Interactive comment on “Effective rainfall: a significant parameter to improve understanding of deep-seated rainfall triggering landslide – a simple computation temperature based method applied to Séchilienne unstable slope (French Alps)” by A. Vallet et al.

A. Vallet et al.

Thank you for considering our manuscript and for your useful review comments. A point-by-point response to the comments is as follows:

Fig. 1.

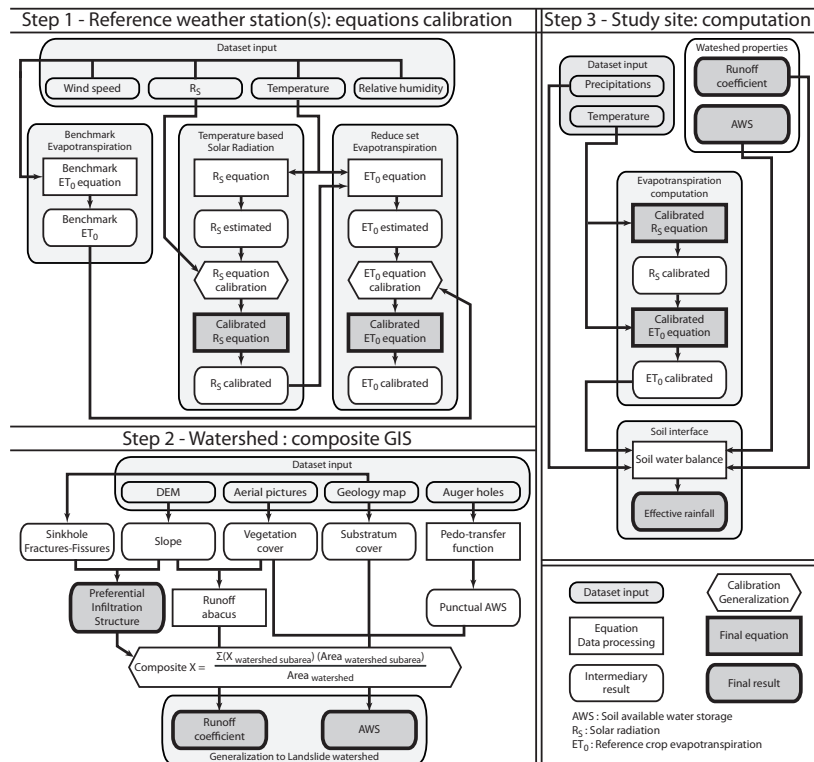
AWS and runoff estimation, developed for this study, involves a wide range of input data (DEM, Aerial pictures, Geology map and auger holes) and combination between them to estimate average value of AWS and runoff at catchment scale. Method used can be qualified as a composite GIS approach, i.e., catchment spatial heterogeneity was taken into account in order to have a spatial average estimation of AWS and runoff coefficient at catchment scale. Preferential infiltration structures (PIS) have been added, to take into account infiltration spatial heterogeneity on catchment as a single parameter. We agree with Dr. Lucca that a summary scheme figure can clarify the method and chapter, so figure 3 of discussion paper was modified to integrate the composite GIS method (Figure 1). In addition this chapter will be modified to clarify the method for the reader.
